HOTCHKISS OFFICE PARK
PUD PLAN No. 05-038
AMENDING

A memo from the
CITY of SAN ANTONIO
Development Services
Master Development

SUBJECT: PUD# 05-038A

Name: Hotchkiss Office Park Amending, PUD

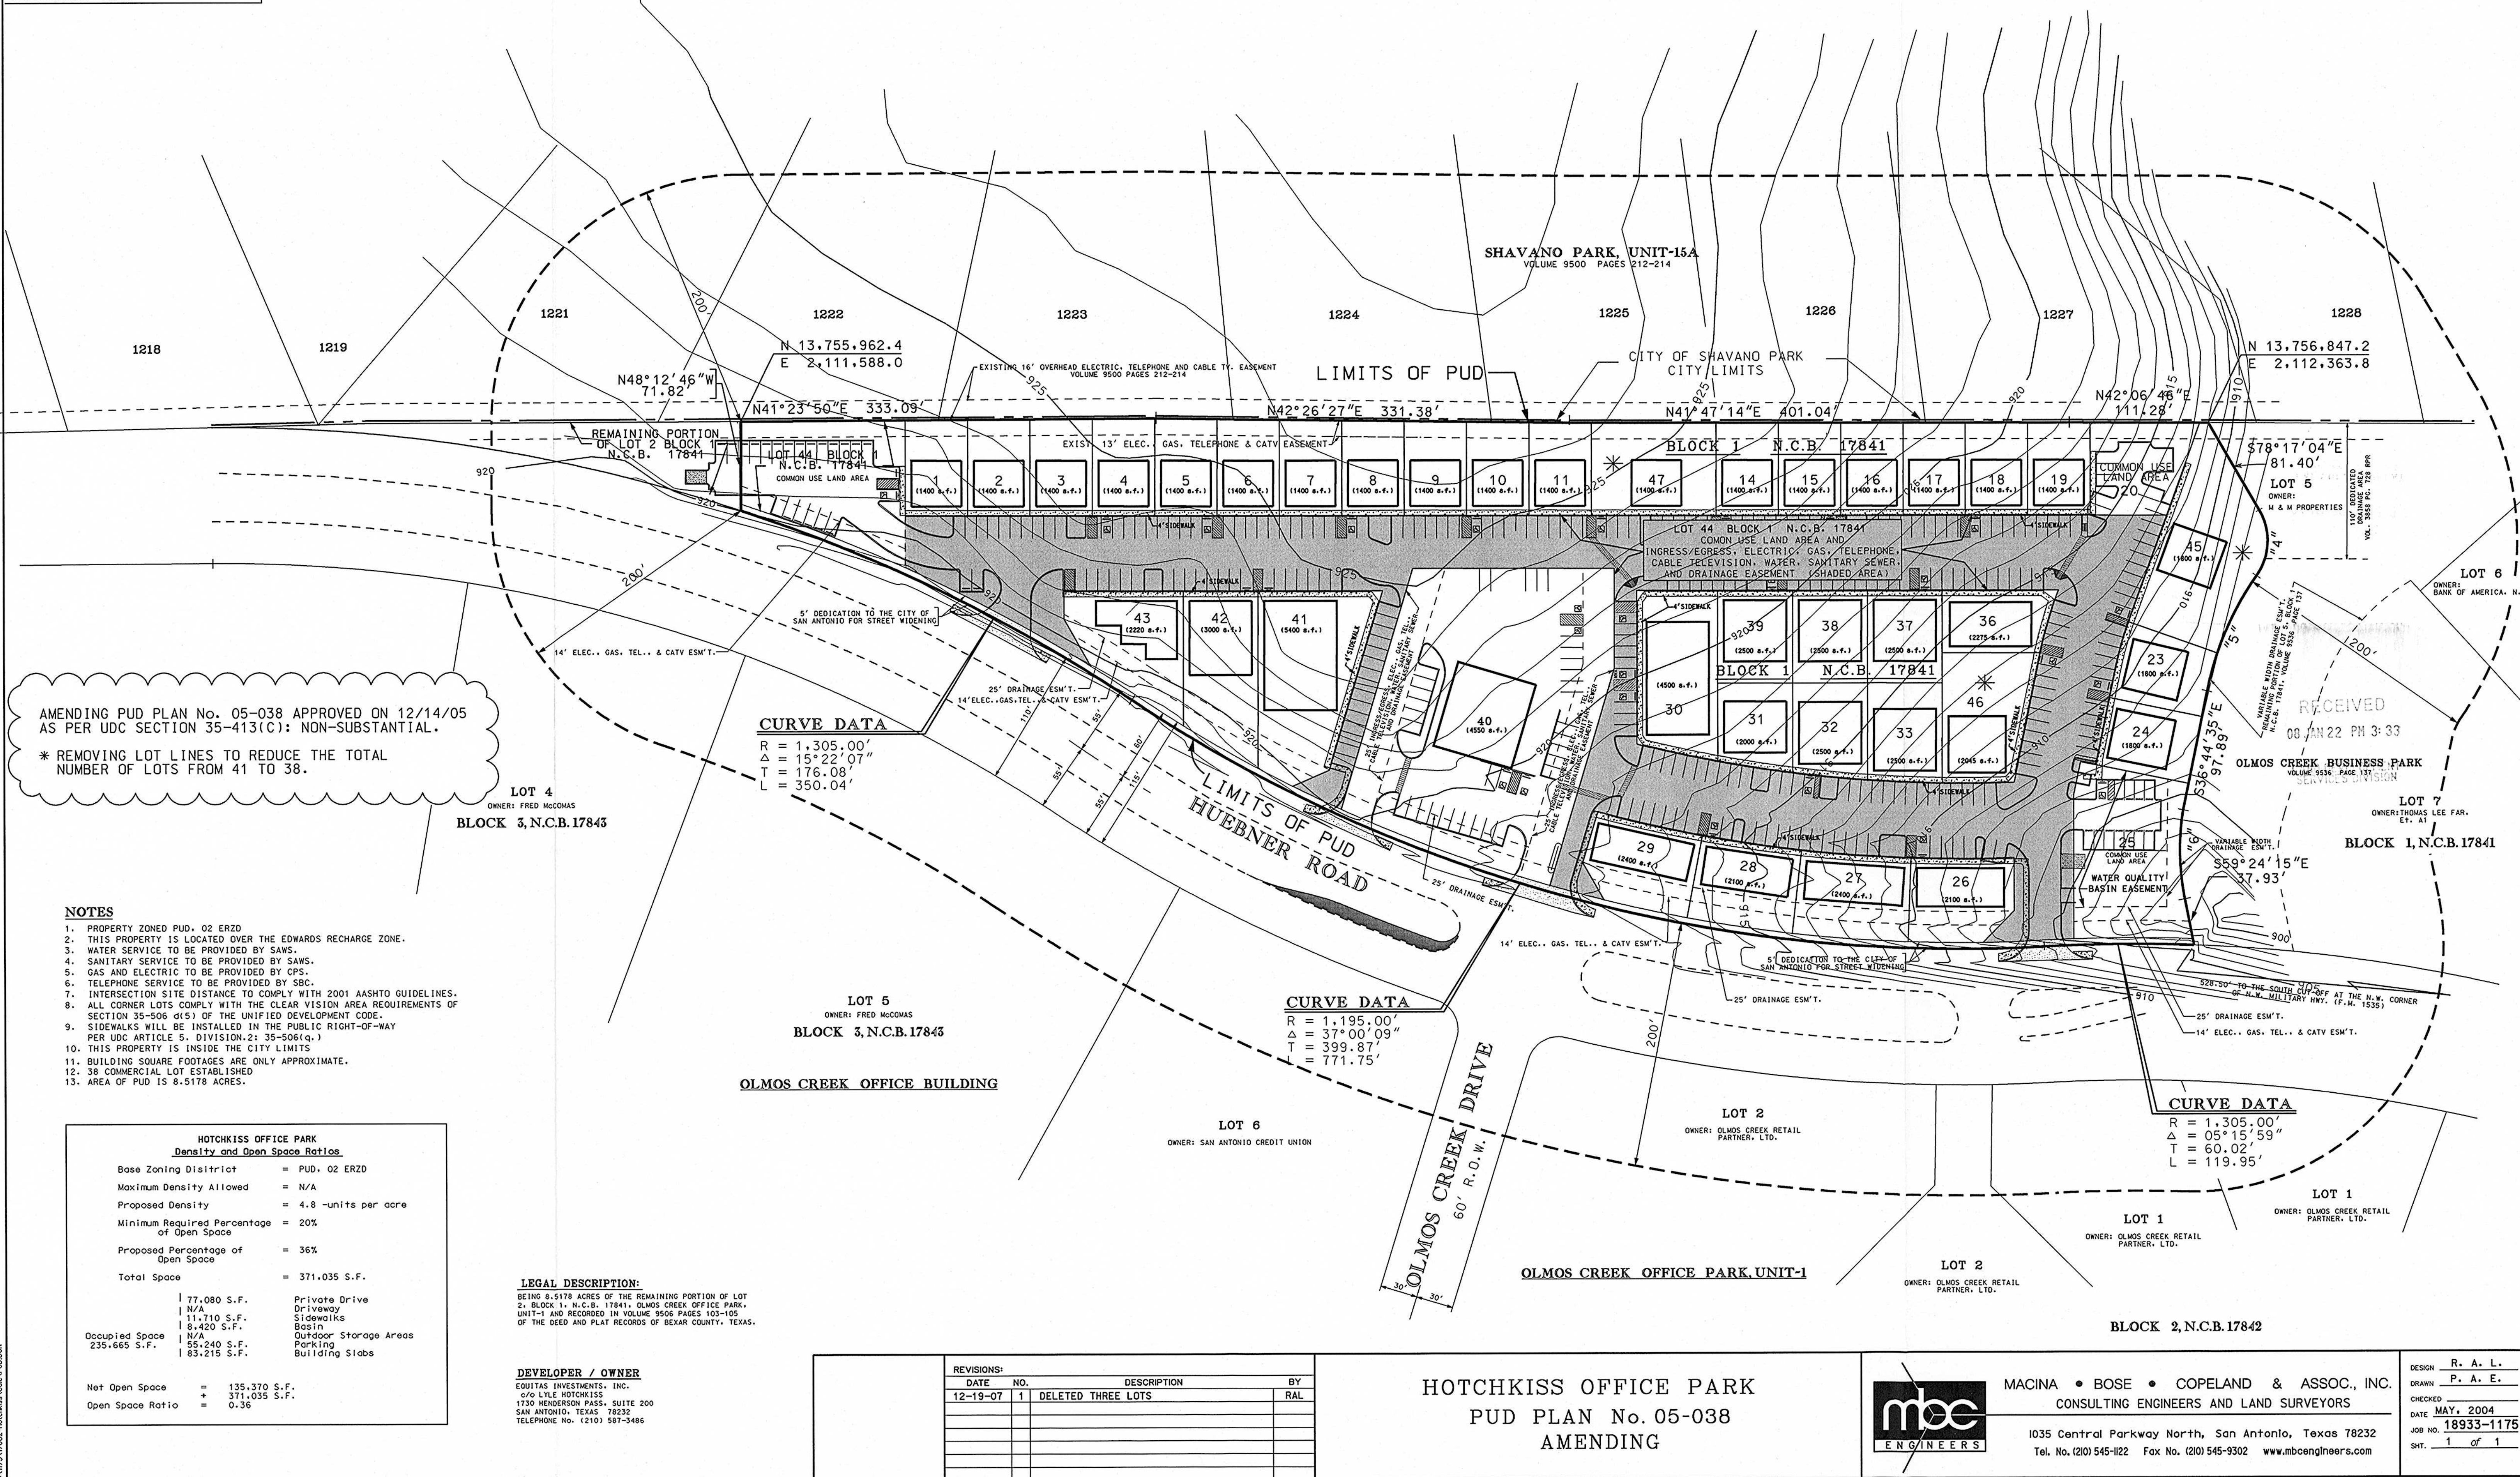
- All access driveways shall provide clear sight distance on all existing and proposed driveways in order to provide adequate obstruction free viewing distances for approaching traffic. All signage, landscaping, and improvements shall be selected and located so as to not block these clear sight distance areas.
- Driveway throat length shall comply with UDC 35-506, Table 506-7 requirements.
- All commercial driveways for this project shall comply with UDC 35-506, (r) Access and Driveways.
- All pavement markings adjacent to proposed development shall be re-painted. UDC 35-502 (7), C

Note: TIA has approved a traffic marking plan for the median opening on Huebner road. This marking plan will allow for efficient movement of traffic, left turns and u-turns.

- 100 year Flood Plain Shown and Buffering (If applicable)
- Significant Recharge Features and Buffering (If applicable)
- Category Letter for All Site Specific Plats (If Category 2 or 3, an Aquifer Protection Plan is required (If applicable))
- Additionally, a Water Pollution Abatement Plan or Contributing Zone Plan must be submitted to and approved by the Texas Commission on Environmental Quality (TCEQ) prior to construction.
